Addendum No. 2 (CBBEL 11/15/2016)

SUBJECT: East Main - System Operation Narrative Sample
(CBBEL Project No. 10-0599)

EXHAUST FAN CONTROL WIRING DIAGRAM

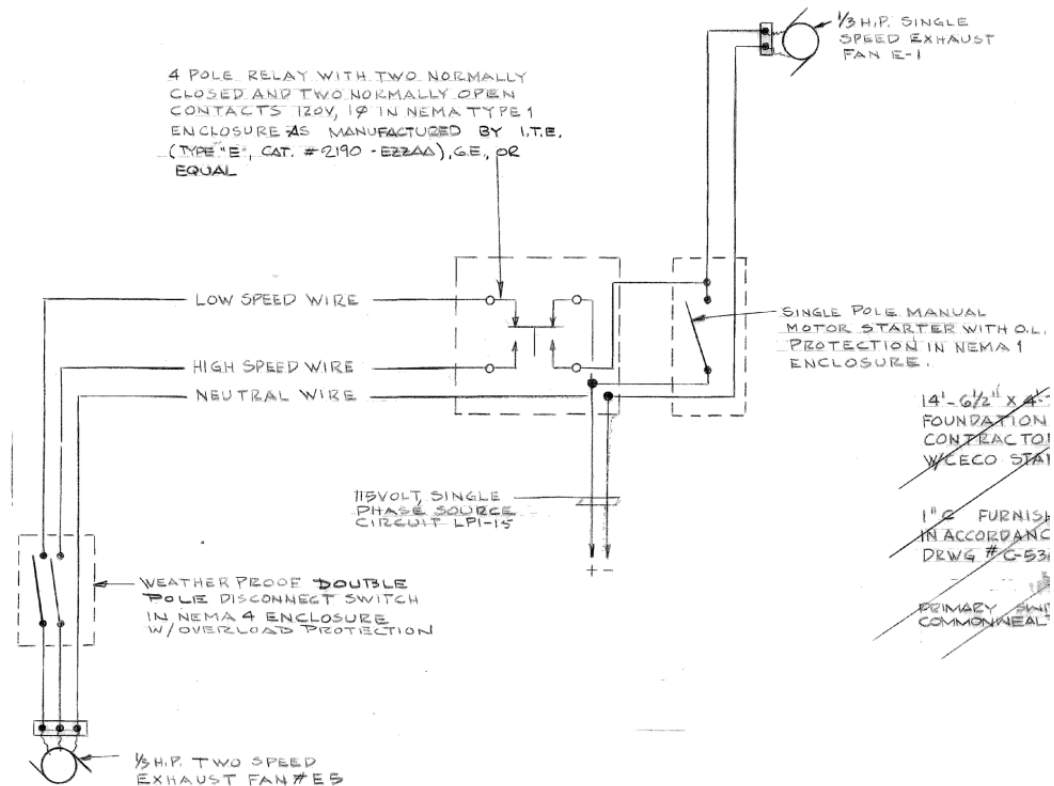
Sheet #23: Note #3, calls out to automate control of existing fan “E-2”. This fan is not called out on the 1-line (sheet 30). Please confirm where this fan is fed from electrically, and if a new motor starter is needed for this fan

R: E-2 is an existing mushroom style fan, roof top mounted above the chimney chase between the Garage and the Control Room, see photo on Drawing 7. E-2 is fed from existing LP1. The original design drawings show 3#12 in a ¾” conduit from E-2 to a 4 pole relay in the screen room (see below). No new motor starter is required.
